Affected Equipment: Omega Container-System XXS, XS, S, SS, M, L und XL

Reason: One or more Lines were entangled with main container flap No. 2
(See drawing page 2)

Entry in the reserve data card: „ Bartec in accordance with Service Bulletin SB-O-200501 “.

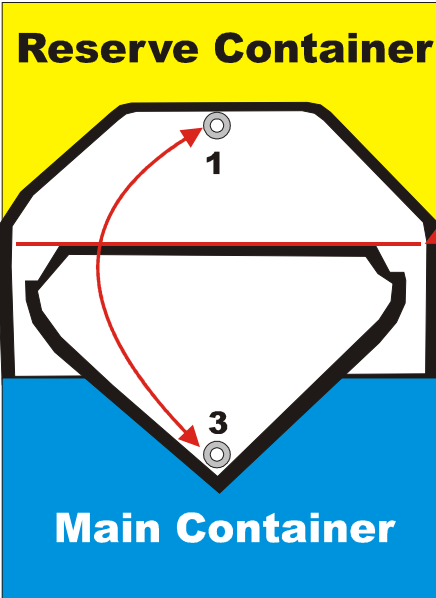
Analysis: A combination of a couple of facts can cause line entanglement with flap No. 2 of the main container.

Reasons for these failure can be:

1. Wrong size or old rubber bands.
2. To much not stowed or misplaced line length inside the main container.
3. Opening of the main container in slightly head up or stand up position.

To avoid failure like written above and during improper use of the equipment in the future, the mirror (Flap No. 3 of the reserve container) must be sewed at the round corners with two short bartec to the flap No. 1 of the reserve container. This avoid contraction of the flap under tension while a line is tucked under. And it is easier to turn up the flap to release a line.

- a. Use only rubber bands in the right size.
- b. Replace all rubber bands after 120 days or 50 jumps.
- c. No not stowed line length longer than 40 cm.
- d. Never place main risers and/or lines in a curve around the corners of the reserve container.
- e. Horizontal, stable body position during pulling the hand deploy and the entire opening of the main parachute.

(This modification can be done by the manufacture or a approved person)

1. Apply the Bartecs bevor the next jump.
2. Visual Inspection of the Bartecs by each packing of the Main Parachute.

Bartec specification see drawing below!

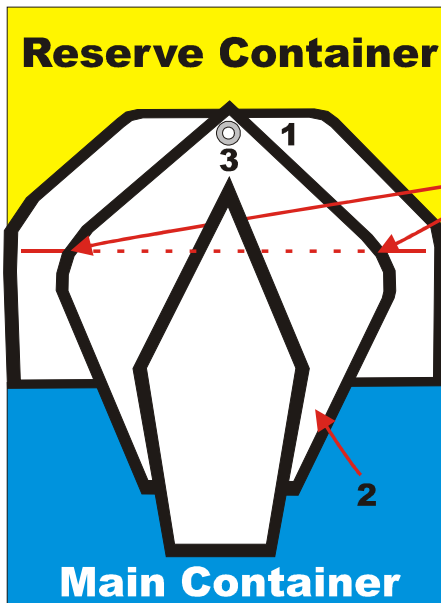
1. Mark out horizontal above the attachment of flap No. 3.
2. Put the grommets congruent on each other.
3. Apply a bartec (left and right) on the binding tape of flap No. 3 in the same height as the horizontal marking.

Use only Typ E / 40, Nylon Bonded thread!

3-4 mm, 42 stitches

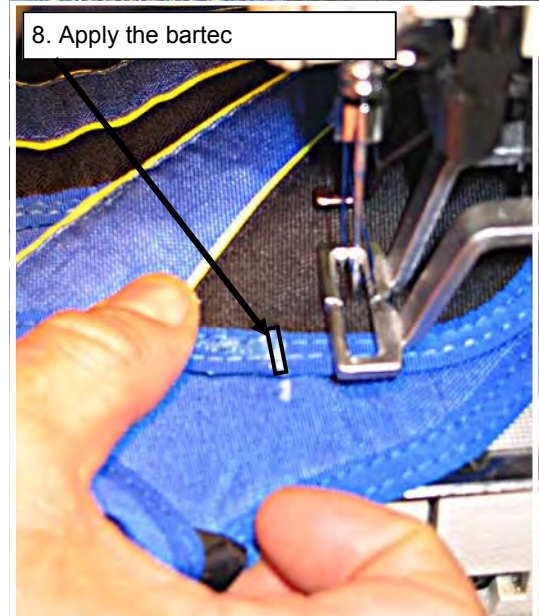
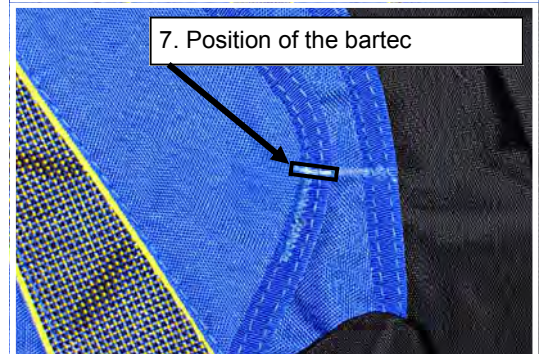
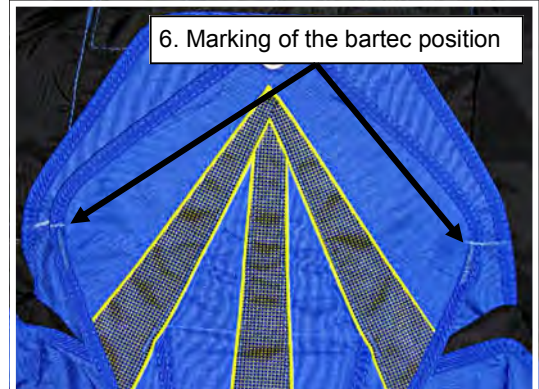
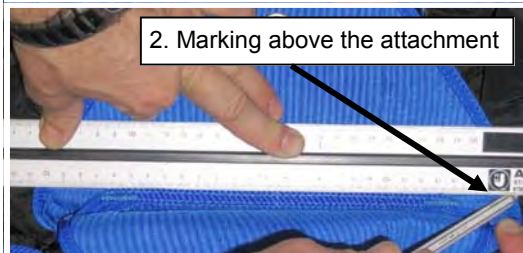
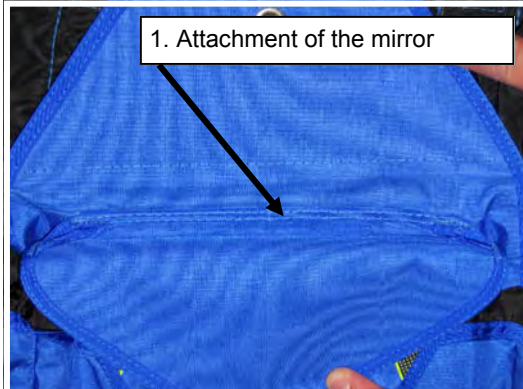
As wide as the binding tape.

9. Prove the bartec

10. Prove the bottom side of the bartec
